**APPENDIX E**  
**COMMENT-RESPONSE DOCUMENT**

This appendix discusses the public participation process for the U.S. Department of Energy’s (DOE’s) *Draft Supplemental Environmental Impact Statement for Disposition of Depleted Uranium Oxide Conversion Product Generated from DOE’s Inventory of Depleted Uranium Hexafluoride (Draft DU Oxide SEIS)*. DOE prepared this appendix in accordance with the *National Environmental Policy Act* (NEPA), the Council on Environmental Quality regulations that implement NEPA (40 CFR Parts 1500 to 1508), and DOE’s procedures for implementation of NEPA (10 CFR Part 1021), as applicable.

**Table E-2 Comment Document Number with Commenter Name and Affiliation, When Provided, Comment and DOE Response**

**FIGURE 3.4.1** Toxicity of Spent Fuel and Reprocessing Waste from Uranium-Plutonium Recycle Relative to 0.2% Uranium Ore Necessary to Produce 1 MT of Reactor Fuel

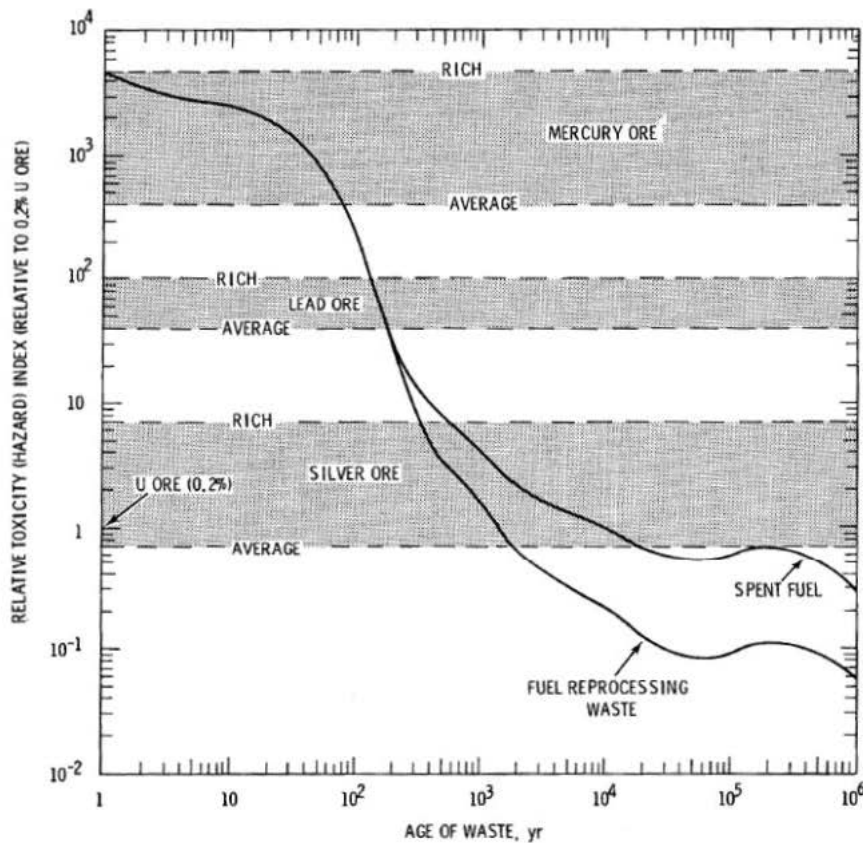
The hazard index for spent fuel and high-level waste is shown in Figure 3.4.1 of the Environmental Impact Statement, together with similarly developed hazard indices for ranges of common ores.

As seen in Figure 3.4.1 the hazard index for spent fuel or reprocessing waste from Uranium-Plutonium recycle relative to the ingestion toxicity of the volume of 0.2% Uranium ore necessary to produce 1 metric ton of reactor fuel is on the order of that for rich mercury ores at about 1 year after removal of the spent fuel. The hazard index is on the order of that for average mercury ore at about 80 years. By 200 years the index is about the same as average lead ore. By 1500 years the relative hazard index for high-level waste is the same as the ore from which the fuel was made. For spent fuel the relative hazard index is about the same as the ore from which it came at about 10,000 years.
